WOLF CREEK

May 3, 2007
WO 07-0012

- Reference:
- 1) Letter ET 06-0004, dated February 21, 2006, from T. J. Garrett, WCNOG, to USNRC
 - 2) Letter dated June 27, 2006, from J. N. Donohew, USNRC, to R. A. Muench, WCNOG
- Subject: Docket No. 50-482: Response to Request for Additional Information Related to License Amendment Request to Revise the Steam Generator Program

**Response to NRC Request for Additional Information Relating to LTR-CDME-05-209-P of the Wolf
Creek Generating Station (WCGS) Permanent B* License Amendment Request**

Figure 17: Plot of Guided Circumferential Crack Opening Area for a Model F SG

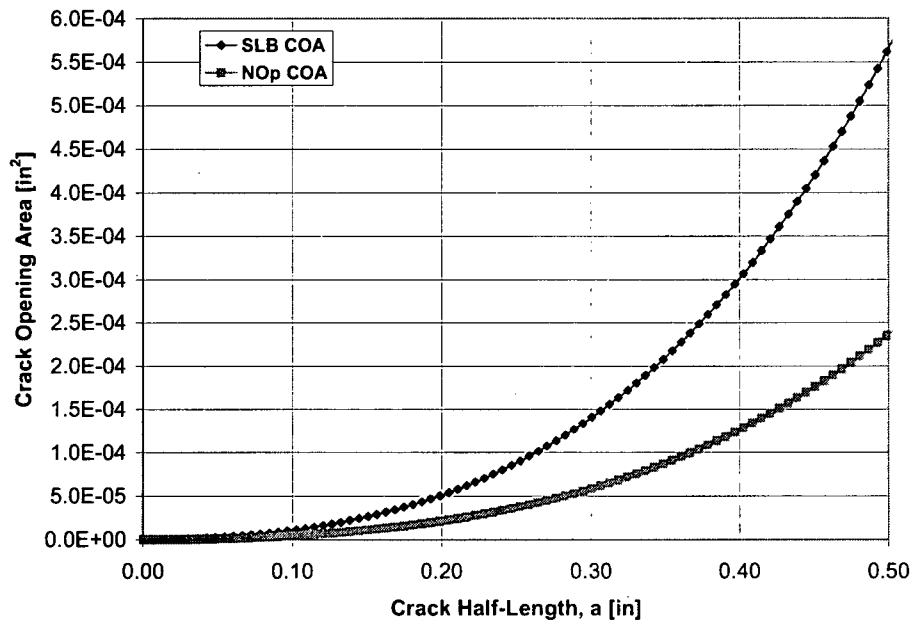
detection, this question is relevant to satisfying the tube integrity performance criteria with respect to condition monitoring and operational assessments.) This assessment should address potential axial and circumferential stress corrosion cracks (SCC) and volumetric intergranular attack (IGA) flaws.

The predicted crack opening area for a guided circumferential crack (constrained from bending, crack opening constrained above the H* depth) 0.24 inch in length, using the models described in WCAP-15932 and illustrated in Figure 17, is approximately 7.5e-6 in² for the NOp condition and 1.8e-5 in² for the SLB condition. These crack opening areas are reduced by an order of magnitude, roughly, for distances below the H* depth.

It is reasonable to consider a value for crack opening area on the order of 10⁻⁵ in², or less, as negligible. This conclusion is consistent with the values for crack opening area that can be calculated using the alternate approach of calculating the kink angle compatibility via methods described in The Stress Analysis of Cracks Handbook (2nd Edition) by Tada. The result of such calculations, given in case 33.1 and 33.2 of the text, show that the crack opening area for circumferential cracks with an angle of less than 40° is expected to be zero. If the crack opening area is negligible, the potential flow through the crack should likewise be negligible. Therefore, since 75% of the cracks in the available database have crack angles less than 40°, corresponding to a crack length of 0.24 inch, these cracks would not contribute significantly to any observed leakage. This analysis also validates the prior conclusion that for any crack that would contribute significantly to leakage, the ratio of leakage at SLB condition to that at NOp conditions will always be less than 2.
